DEVELOPMENT CONSENT AUTHORITY
LITCHFIELD DIVISION

AGENDA ITEM: 5 **MEETING DATE**: 18/11/2026 **FILE**: PA2026/0209

APPLICATION PURPOSE:	Dwelling-Independent with a floor area in excess of 100m^2
SUBJECT SITE:	Section 4749 (75) Varro Road, Lloyd Creek, Hundred of Strangways
ZONE:	RL (Rural Living)
SITE AREA:	2 ha
APPLICANT:	MJJ Carpentry Pty Ltd
PERSONS ON WHOSE BEHALF THE APPLICATION IS MADE:	Gareth Martin Bosse and Hannah Leanne Bosse
LANDOWNER(s):	Gareth Martin Bosse and Hannah Leanne Bosse
ANY PERSON WITH AN AGREEMENT TO ACQUIRE AN INTEREST IN THE LAND:	None

Site Plan
SCALE 1 : 1000

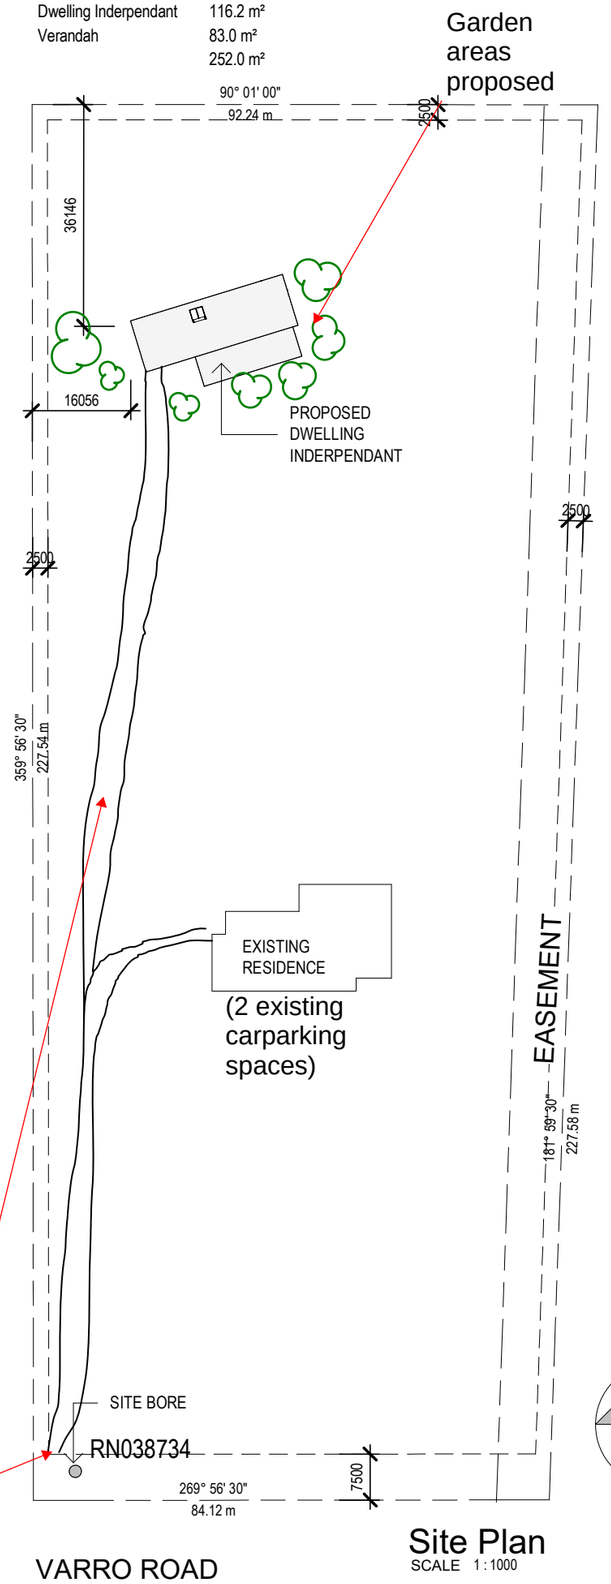
b) The provided site plan does not show the existing 'shed' and other structures on the property. The property owner is urged to ensure that all structures on the property comply with Building regulations and Bushfires NT.
